ADDENDUM

NO. 1

PROJECT NAME: Tomball ISD Intermediate School Replacement

ADDENDUM DATE: Tuesday, July 28, 2026

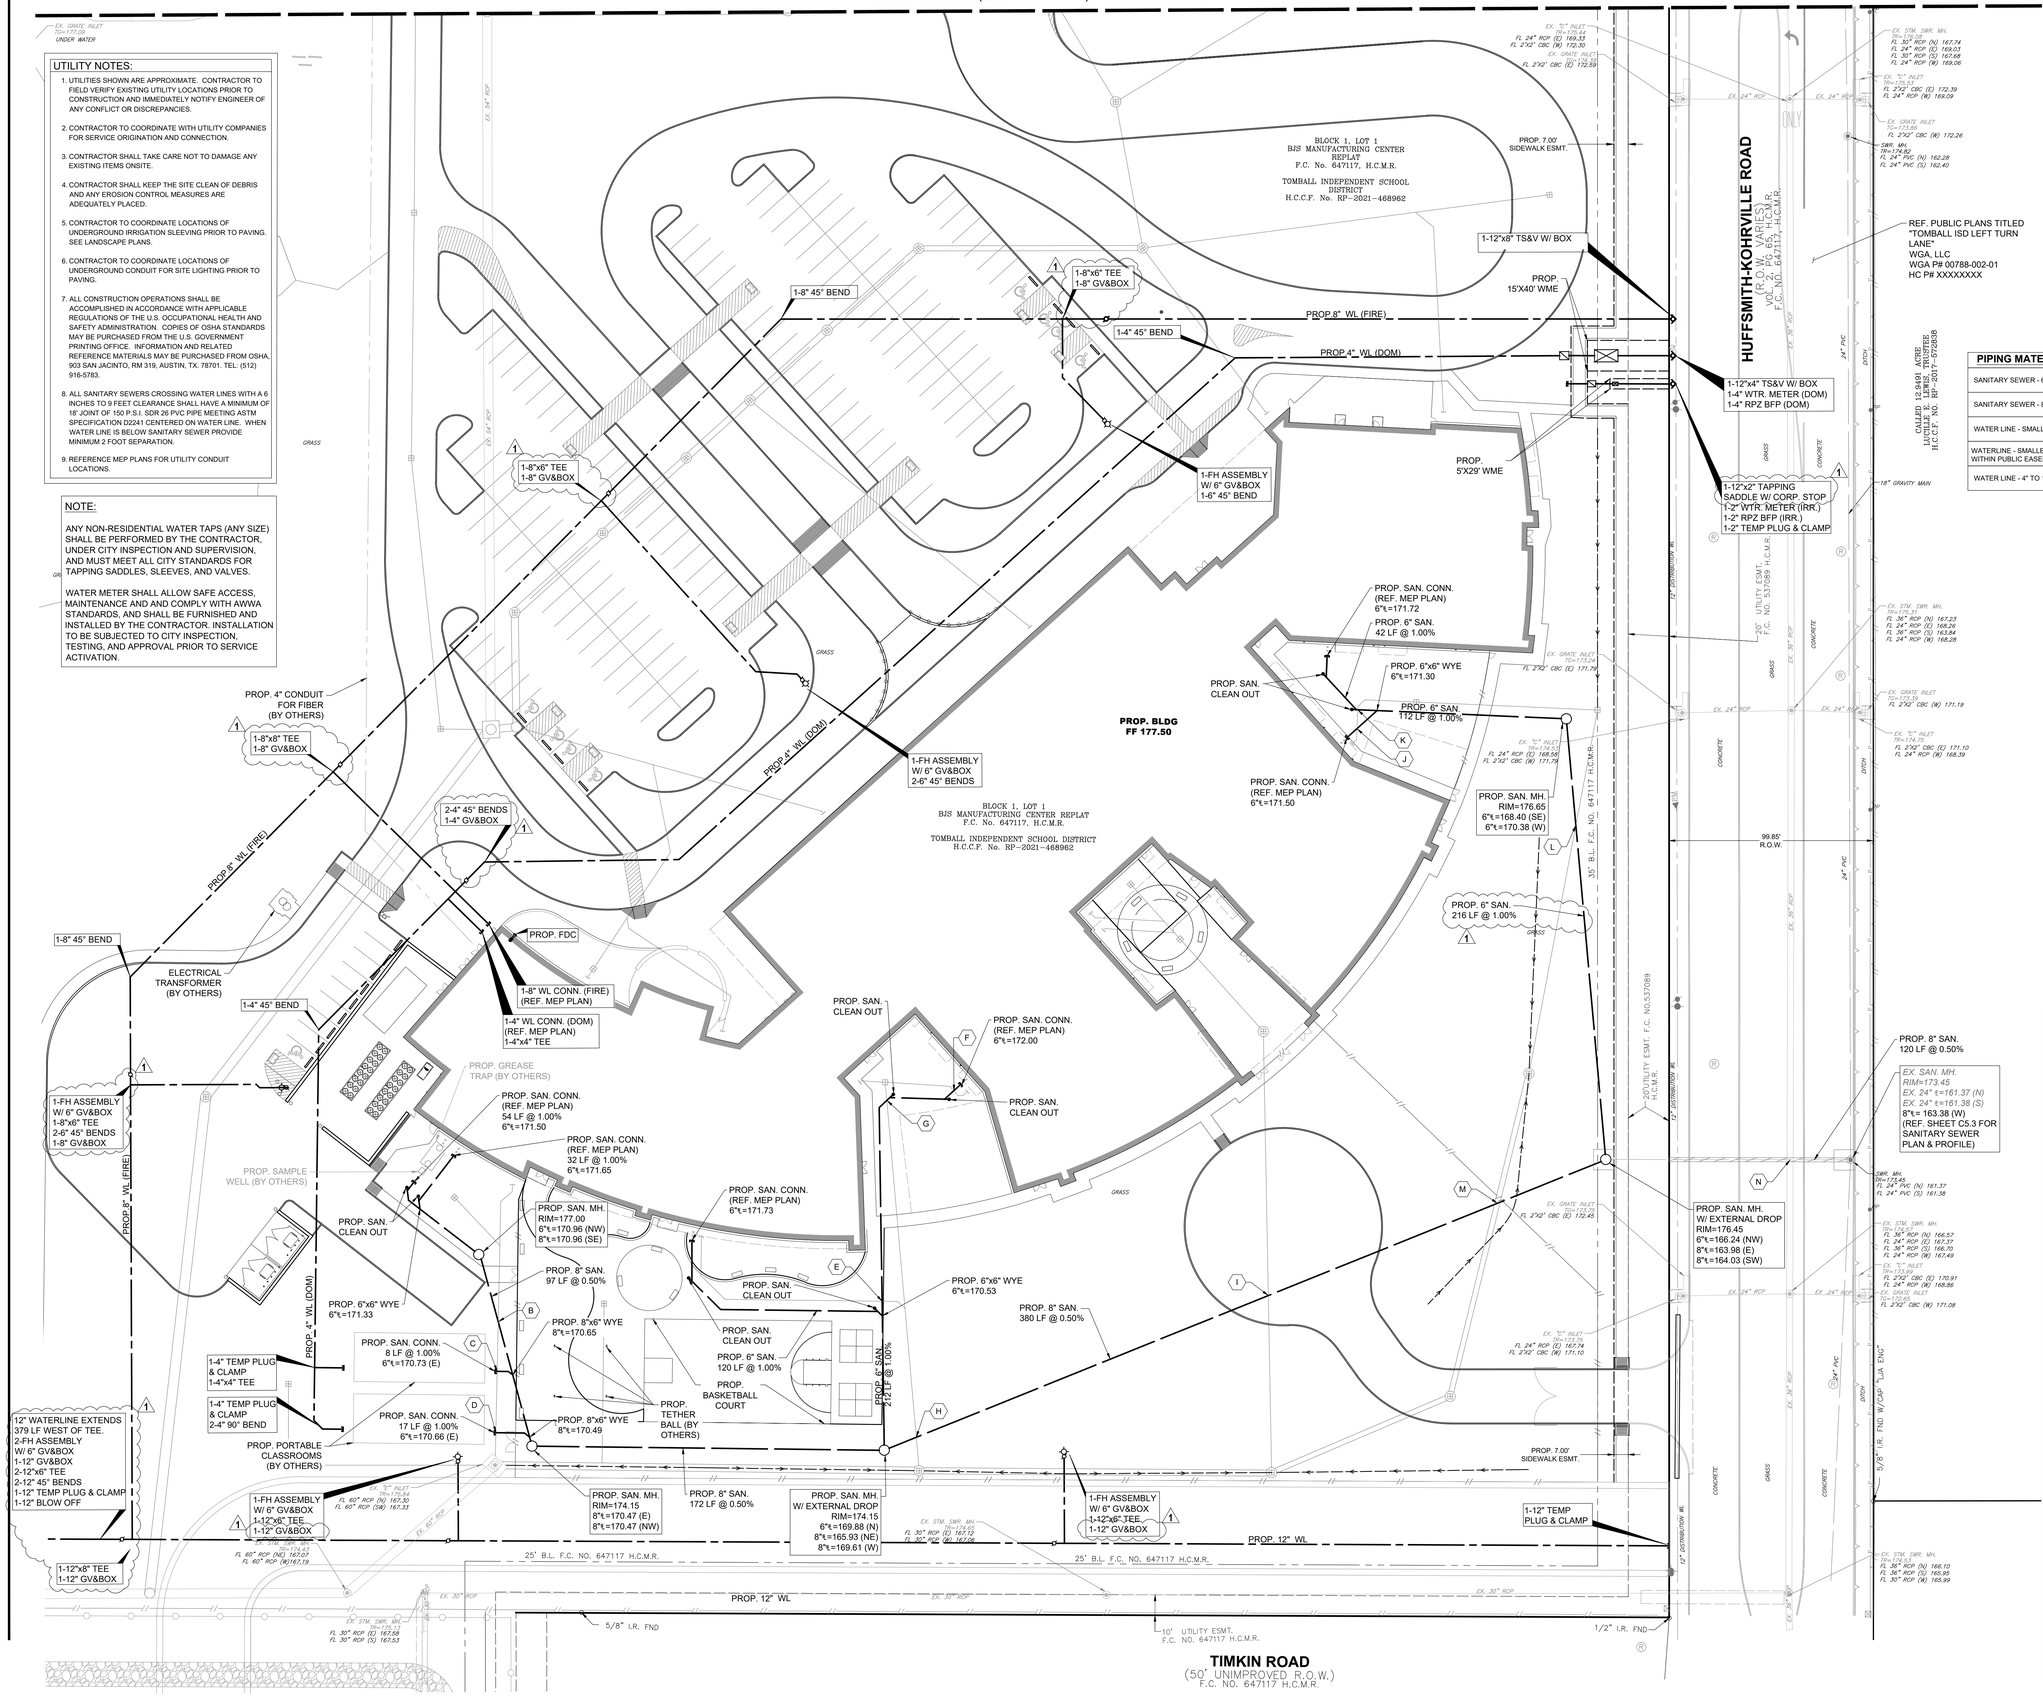
AD No 1, Civil. Item 8: **To the Drawings, C5.2, "UTILITY PLAN – WATER & SANITARY (2 OF 2)"**
Description.

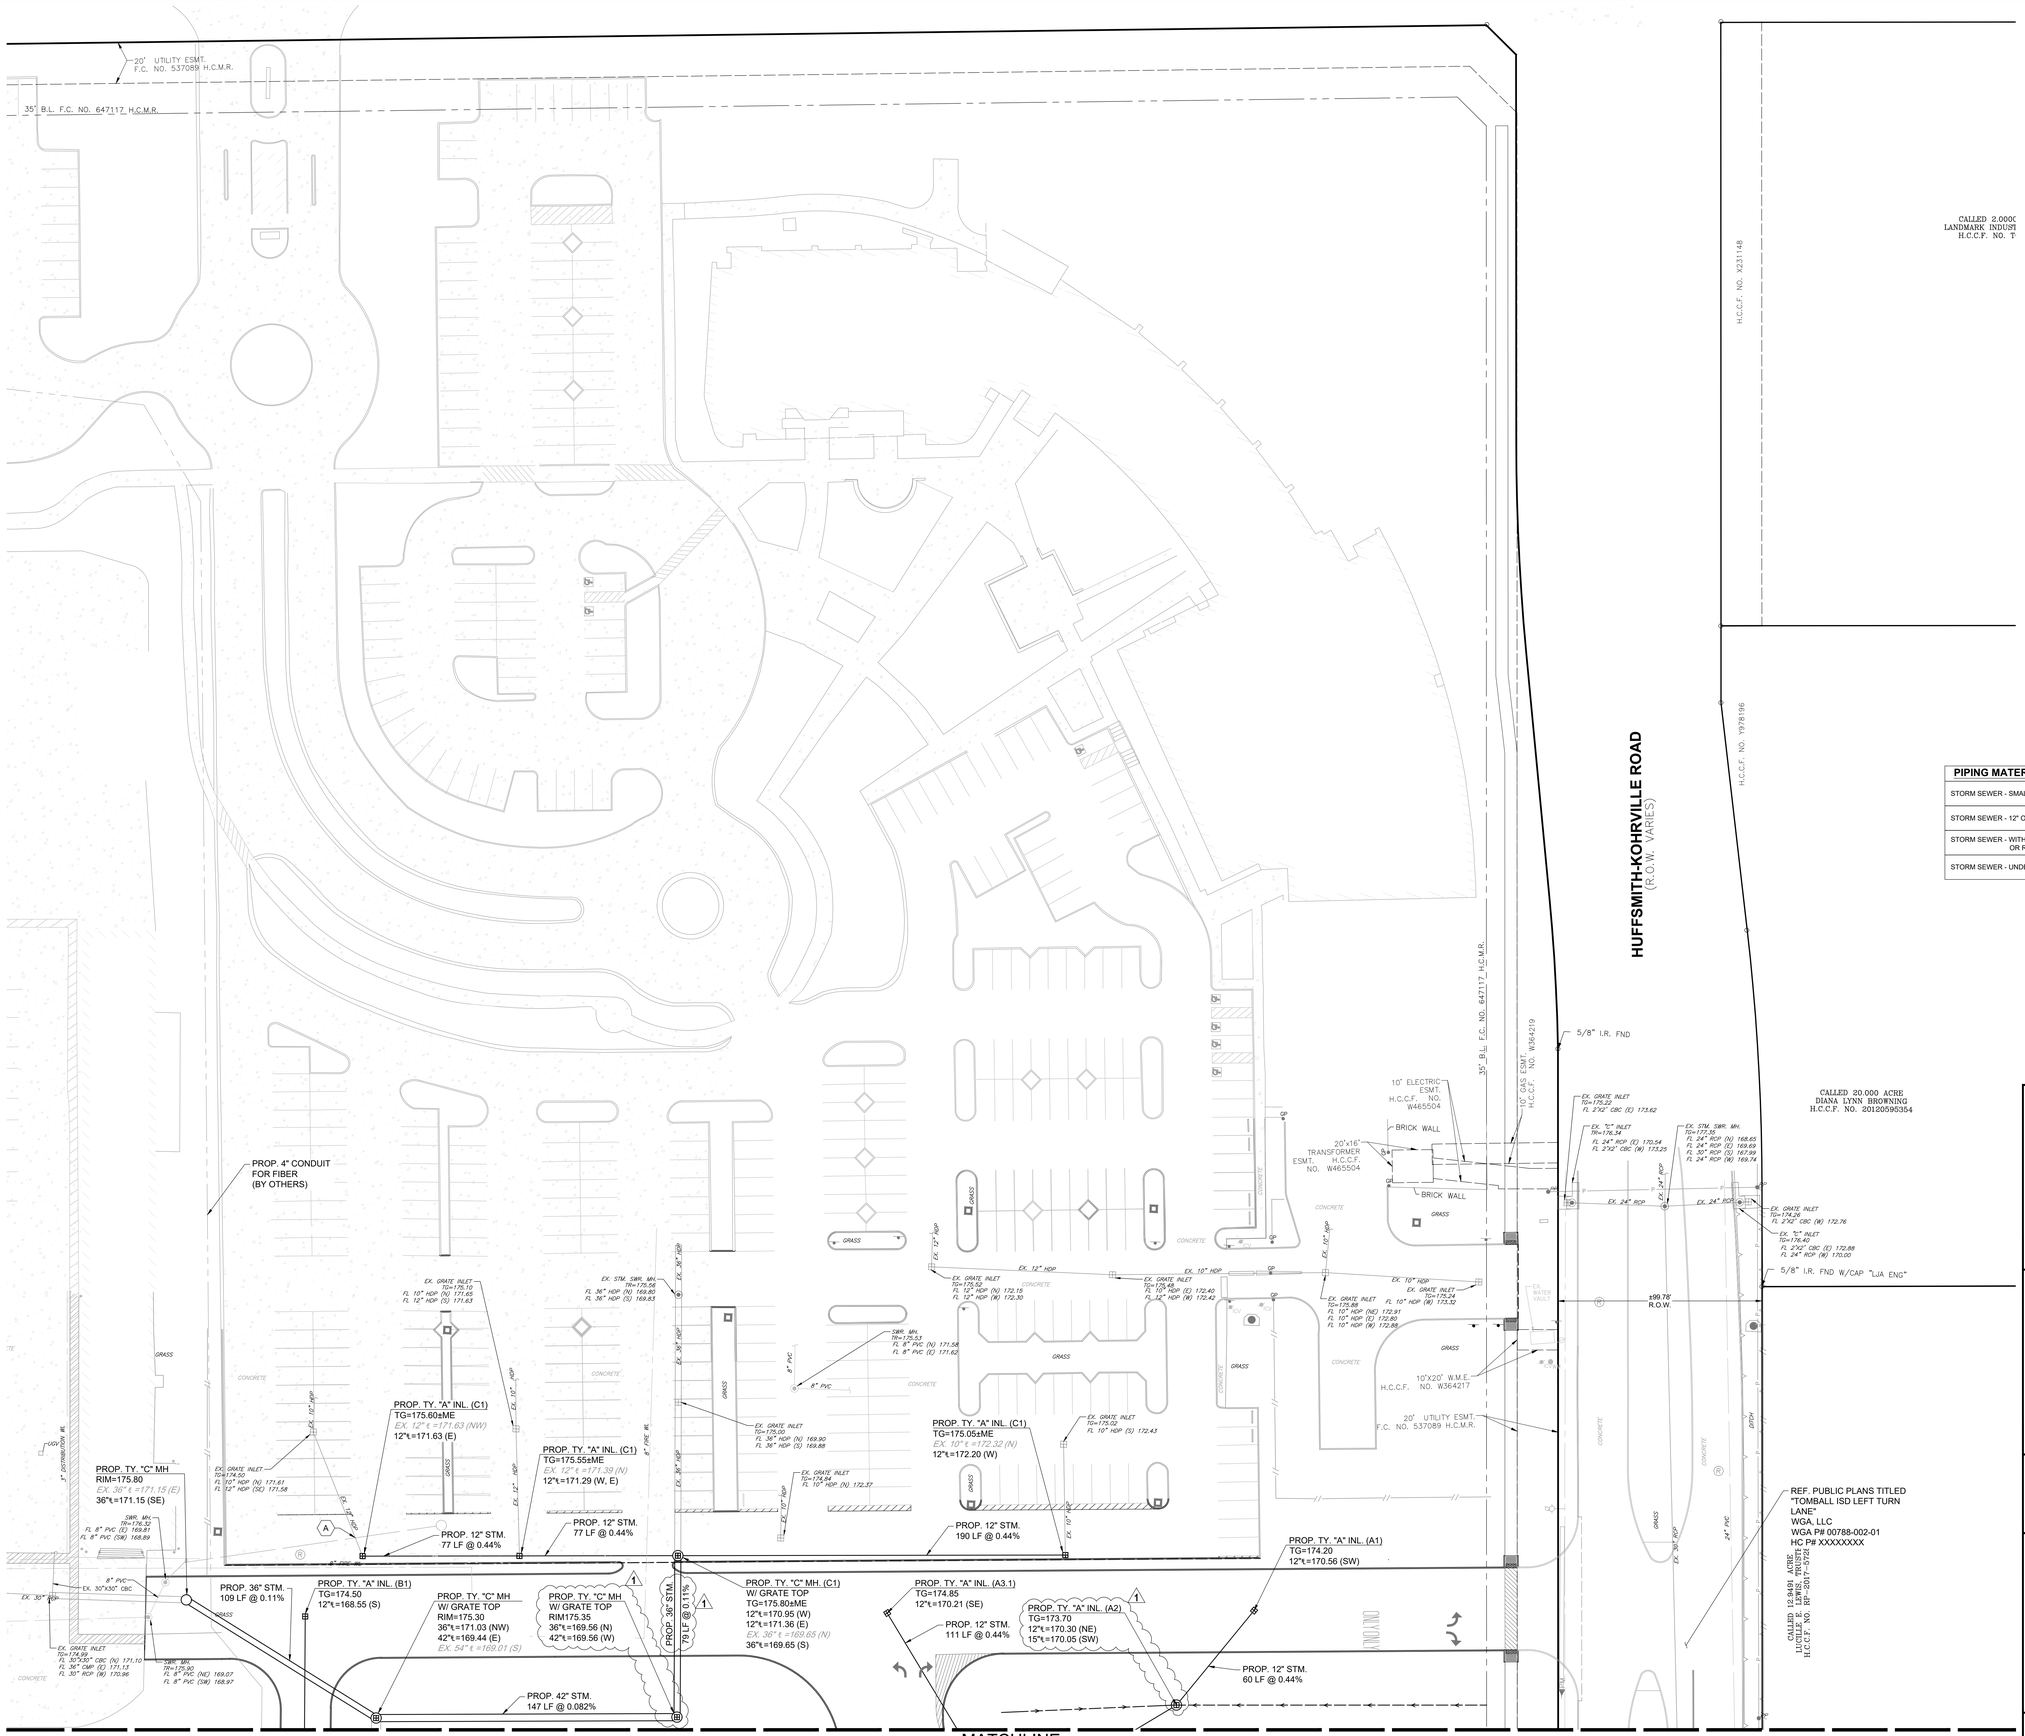
- Tetherballs proposed by others have been relocated.
- Inlet orientations have been revised to be parallel to the storm sewer, where applicable. Please refer to Sheets C6.1 and C6.2.

AD No 1, Civil. Item 9: **To the Drawings, C6.1, "UTILITY PLAN – STORM SEWER (1 OF 2)"**
Description.

2 L1.2 **ENLARGEMENT OF PLAYGROUND LANDSCAPE PLAN**
SCALE: 1" = 10'-0"
SCALE: 1"=10'

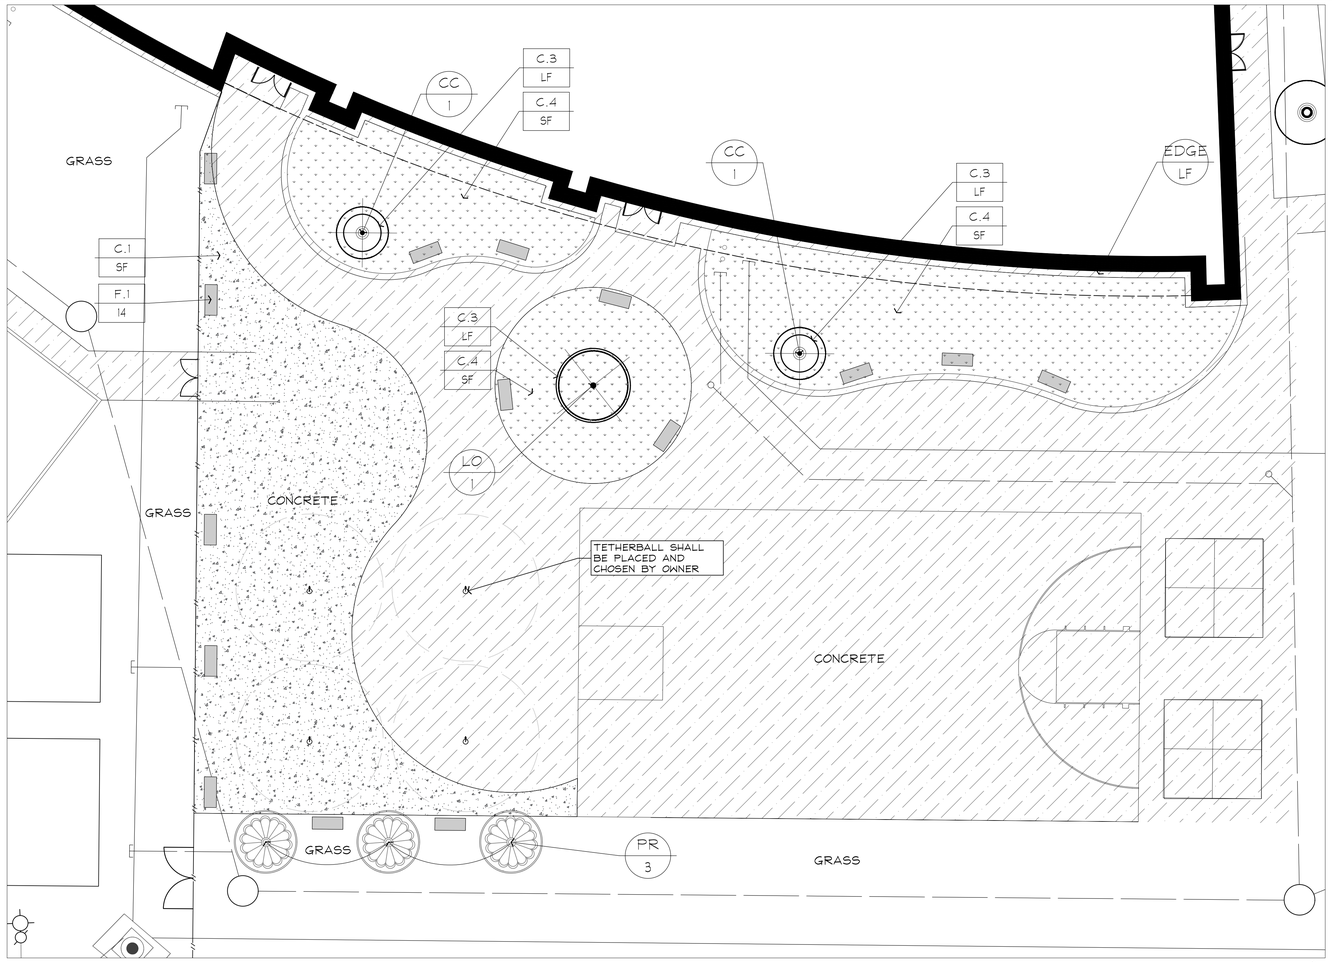
AD No 1, Land Item 1: **To the Drawings, Sheet L1.2, "ENLARGEMENT LANDSDCAPE PLAN"**
Paving and landscape adjusted to coordinate with new fence line. Tree and bench locations have been adjusted to this as well. Landscape and Hardscape legends have been updated with more information on types and finishes.
Details for concrete bench locations and conditions have been added as well as details on artificial turf installation.

1 ARCHITECTURAL SITE PLAN - OVERALL
1" = 30'-0"

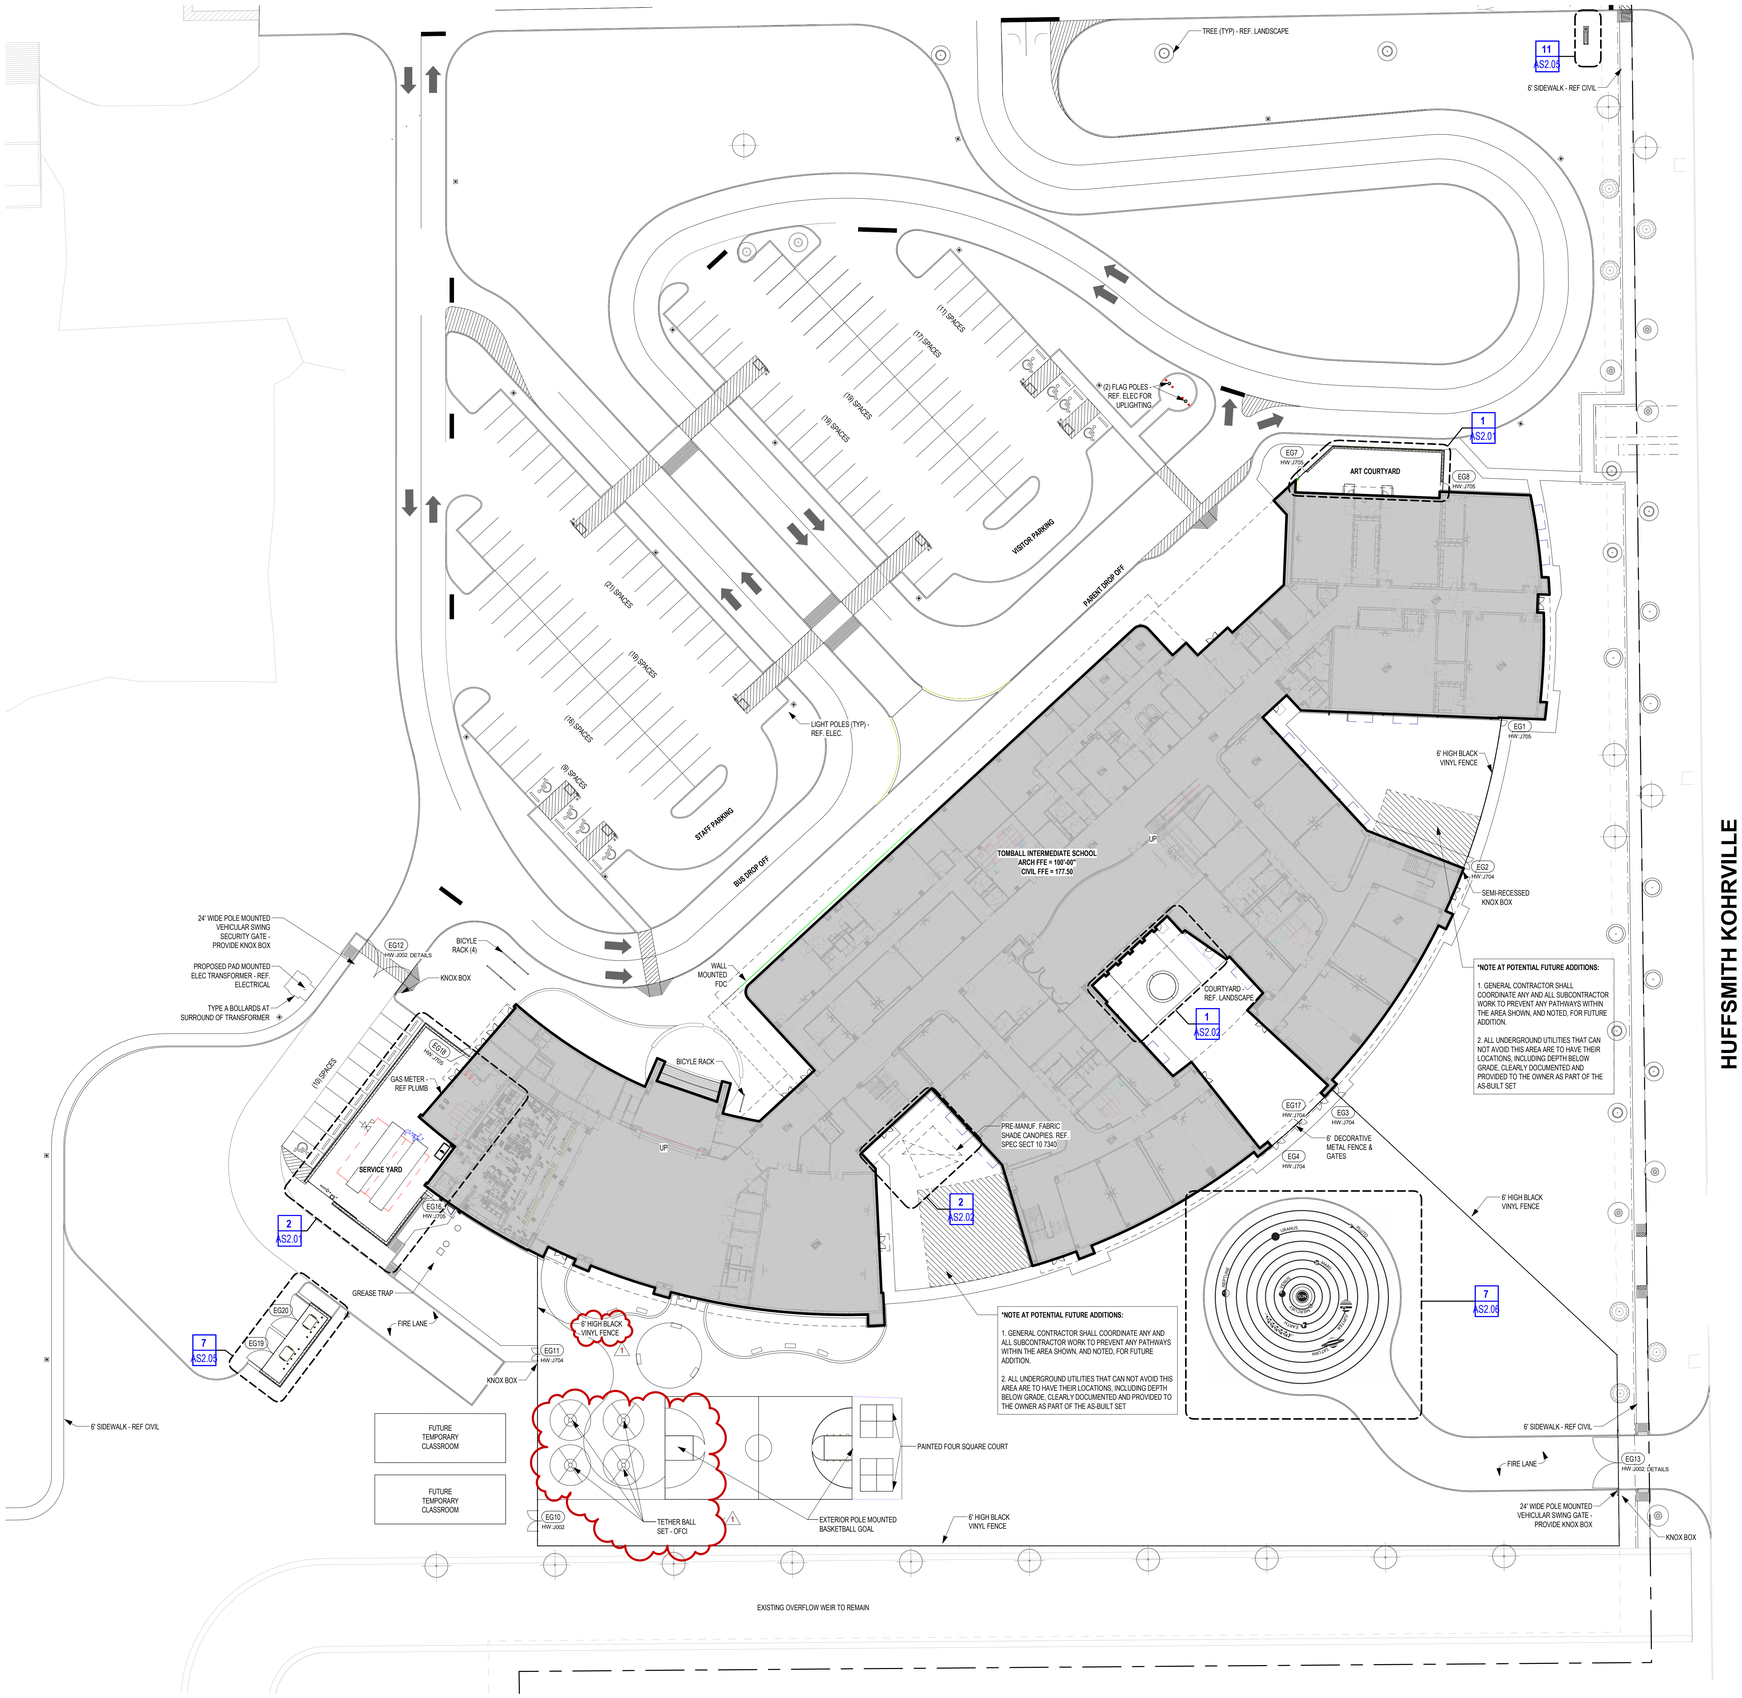
AD No 1, Arch. Item 3: **To the Drawings, Sheet AS1.02,"ENLARGED SITE PLAN"**
Updated west fence to be 6' H to match other site fence.
Updated perimeter of site finishes to align with west fence.
